UNITED STATES PATENT AND TRADEMARK OFFICE

APPLICATION NO.	FILING DATE	FIRST NAMED INVENTOR	ATTORNEY DOCKET NO.	CONFIRMATION NO.
10/716,535	11/20/2003	Nicolas Roux	245509US41X CONT	6889

Office Action Summary	Application No. 10/716,535	Applicant(s) ROUX, NICOLAS	
	Examiner Kevin M. Nguyen	Art Unit 2629

FIG. 4.

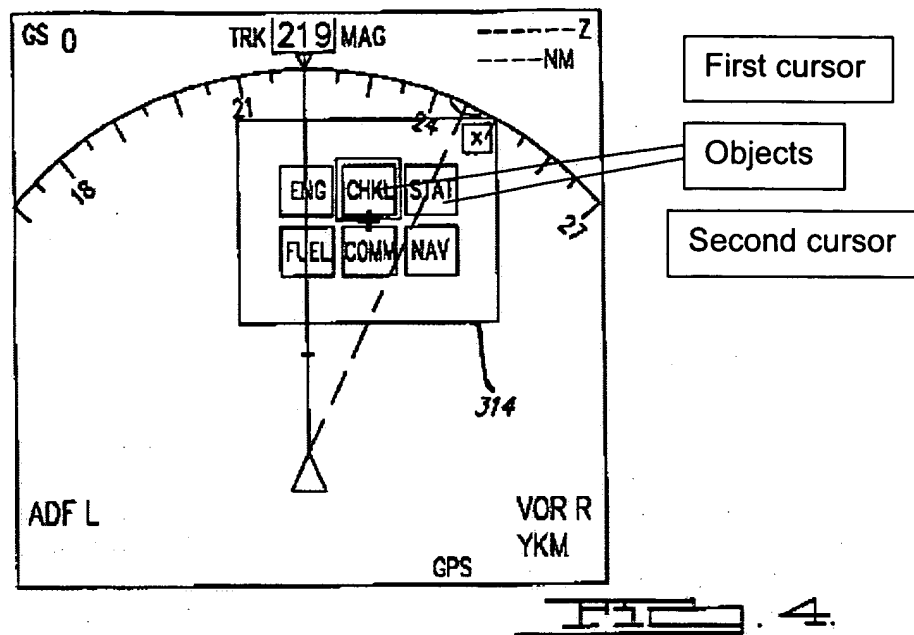
26. Applicant argues with respect to claims 1 and 12 recited "an auxiliary cursor discretely in the display from one responsive object to another responsive object" see remarks at pages 12 and 13. In response, the examiner respectfully disagrees. As stated *infra* with respect to claims 1 and 12, the examiner finds that Clark discloses "pressing a switch, 212a₁, 212a₂ or 212a₃, once would jump the cursor on display in the direction indicated. Holding the switch depressed would jump the cursor from display to display to display in the direction shown" see col. 6, lines 26-30. Accordingly, the feature "jump the cursor" corresponds to "moving cursor discretely" as claimed. As indicated the figure 4ⁱ given below, a first cursor corresponds to an auxiliary cursor, which moves discretely from one responsive object to another responsive object as recited claims 1 and 12 (see col. 5, lines 29-50 for further details of the explanation).
